CORRIGENDUM- 05

PROJECT	:	(3X200 MW+3x500 MW) RAMAGUNDAM STAGE-I & II FGD
PACKAGE	:	GYPSUM DEWATERING SYSTEM
TENDER ENQUIRY NO	:	PE/PG/RGM/E-6515/2020 Dt. 05/09/2020
SUBJECT	:	REGARDING REPLY OF PRE BID QUERY

PRE BID CLARIFICATIONS - 1

TITLE: P & ID-GYPSUM DEWATERING SYSTEM (WASTE WATER TANK)
SCALE: NTS

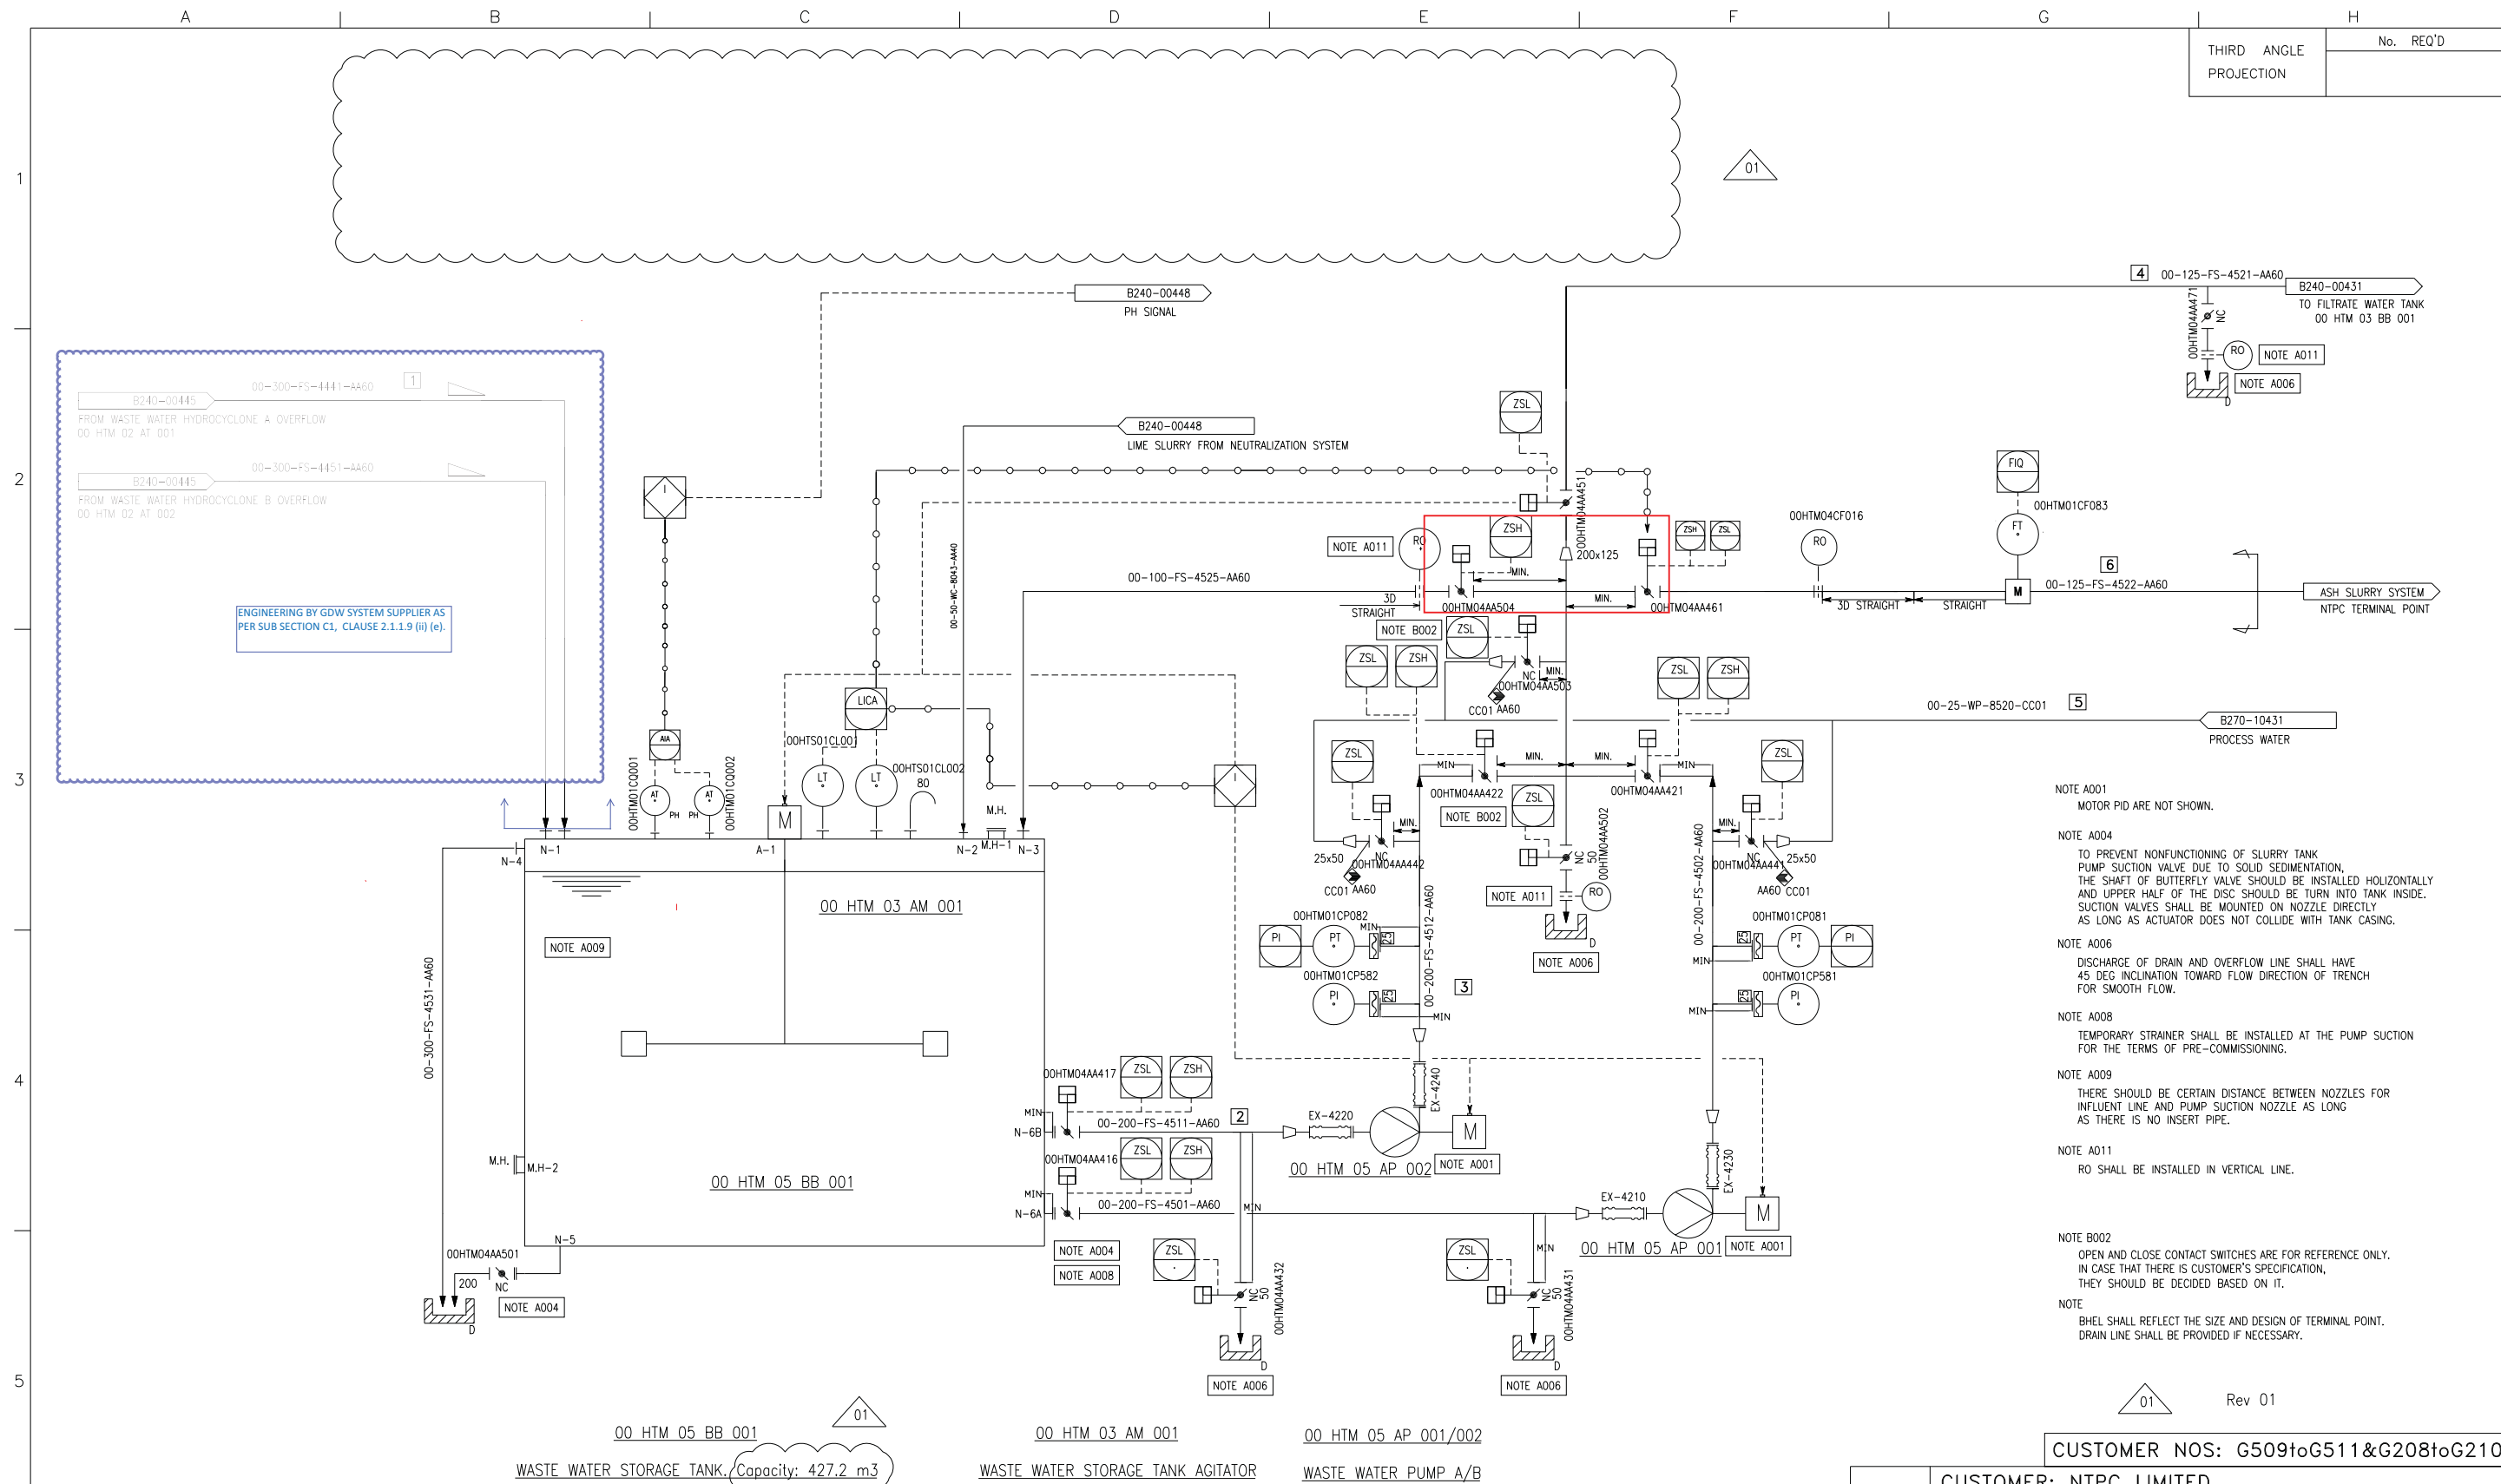
Feed slurry solids composition will be shared during detail engineering.
75					P&IDs for Bidder's scope of Engineering as per Clause 2.1.1.9 (ii) (d), (e) & (f) are enclosed as Annexure-C to this pre-bid clarifications.
